**Z-54
(2012)**

BANKSTONE PRESERVE

PETITION NO: Z-54

ZONING COMMENTS:

SHEET TITLE
ZONING PLAN

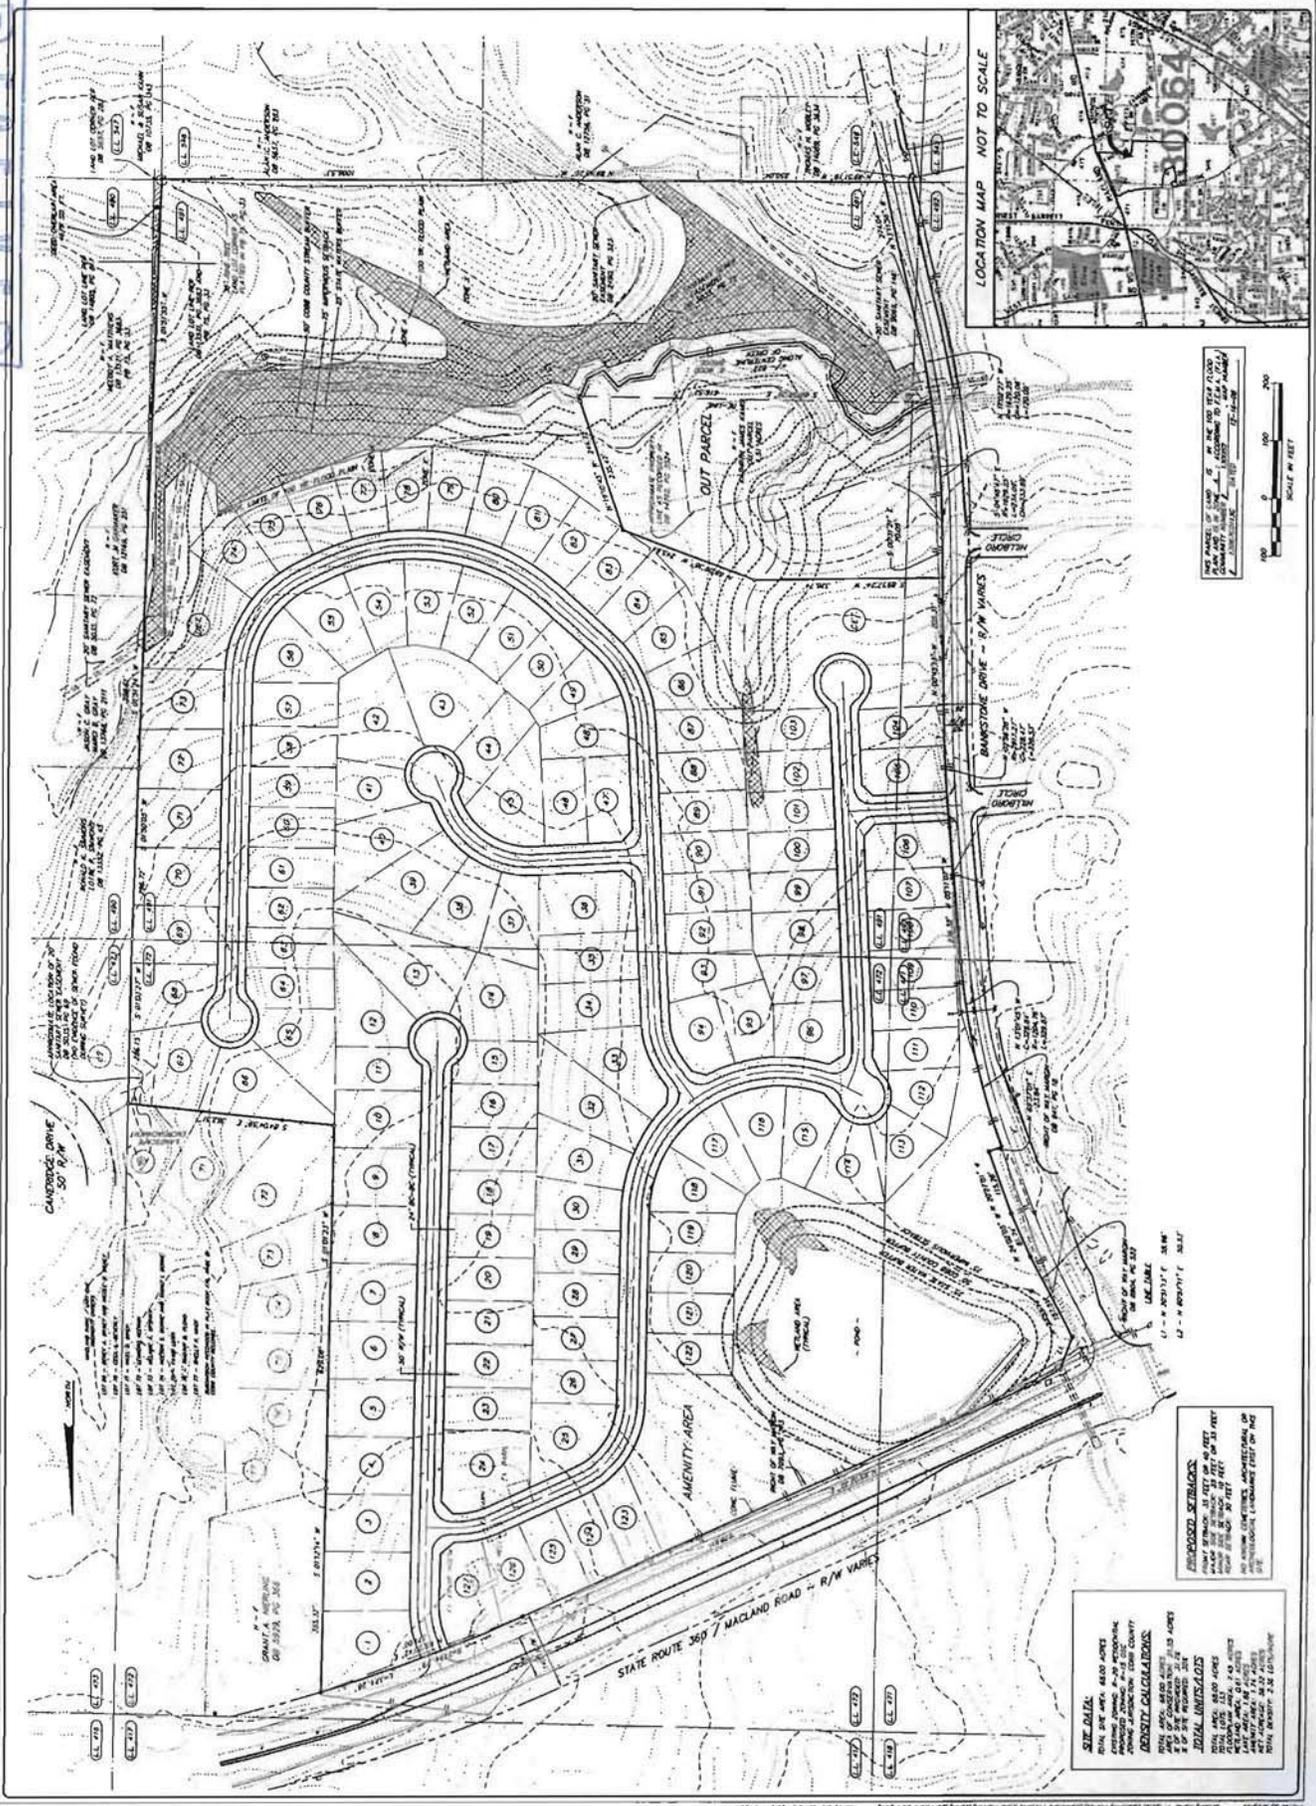
1. Need to correct site data figure. Site data box shows 133 lots when 127 lots have been drawn out on the site plan. All above calculations are based on 127 lots.
2. Net Density is 2.25 upa, which is right at the maximum density allowed with bonus. However, to achieve the bonus there must be 33% or greater open space. Site Plan dated received October 4, 2012 contains 31.7%. Therefore, proposal currently exceeds the base density allowed for R-15 OSC.

Need to add another 1.3% of open space or decrease the density to 2.1 upa.

- 3. Need to note on site plan whether or not Amenity area is to remain natural, as this will effect open space calculations. If Amenity area remains natural it may be calculated as part of open space. Currently, it does not appear to be part of the open space and has been subtracted out of the total area per Site Plan dated received October 4, 2012.

- 4. To ensure compatibility with lots adjacent to existing neighborhoods, lots 68 through 73 should be reconfigured to be more compatible with adjacent lots to the east.

- 5. Please note minimum, maximum and average lot sizes on site plan
- 6. Provide site plan that delineates and gives description of ground cover types and locations of specimen trees as defined in the county tree ordinance or specific healthy trees greater than 8 inches caliper, as measured from their outermost drip line

1. This site is located southeast of the intersection of Macland Road and Bankstone Drive. The majority of the site drains to the south to small tributary to Noses Creek. The remainder of the site (~15%) drains to the northwest to an existing lake in the northwest corner of the site. The site is a mixture of pasture and woodland with gentle slopes that average less than 10%.
2. The existing dam on the site does not appear to have a functioning principle spillway. The dam will need to be brought up to County Standards with adequate spillway design capacity.
3. Lots 74-78 do not appear to meet the required 12,500 sf minimum lot area above the floodplain. Field run topo will be required to verify the floodplain delineation in this area or the lot lines will need to be revised.
